AIMOC WIM

03 - Static inbound + static outbound

Modular static: 80 t x 20 kg; pitless modular

Source: customer-supplied technical PDF, pages 3-9. Quoted prices and personal contacts are not published.

PLAN · TWO STATIC STATIONS

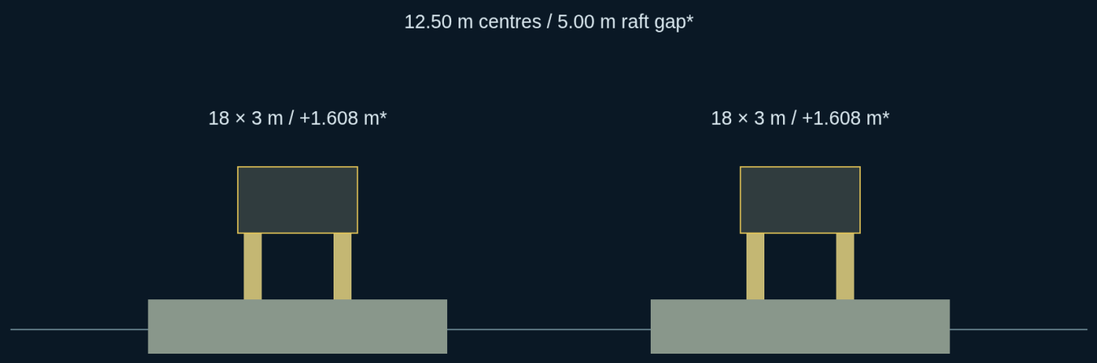
*Coordination: two 28 × 7.5 m rafts; two 52.32 m footprints; loop/holding excluded.

SECTION · TWO SEPARATE FOUNDATIONS

*Levels, raft and ramps are assumptions, not OEM foundation drawings.

Civil assumptions: 28 x 7.5 x 0.35 m raft; 100 mm pedestal; 100 mm mount; 308 mm module. OEM reinforcement, concrete grade, anchors and bearing design are not supplied. Verify settlement, flooding, drainage, corrosion and adjacent-foundation interaction before construction.

The simulated 28 × 7.5 × 0.35 m raft, levels and ramps are coordination assumptions. Check CPT/SPT, settlement, adjacent static interaction, drainage/flooding and excavation limits.

The 3 m nominal platform differs from the 3.2 m overall drawing width. A 3.2 m truck is on engineering hold until tyre positions, guard-rail clearance and swept envelope are approved.
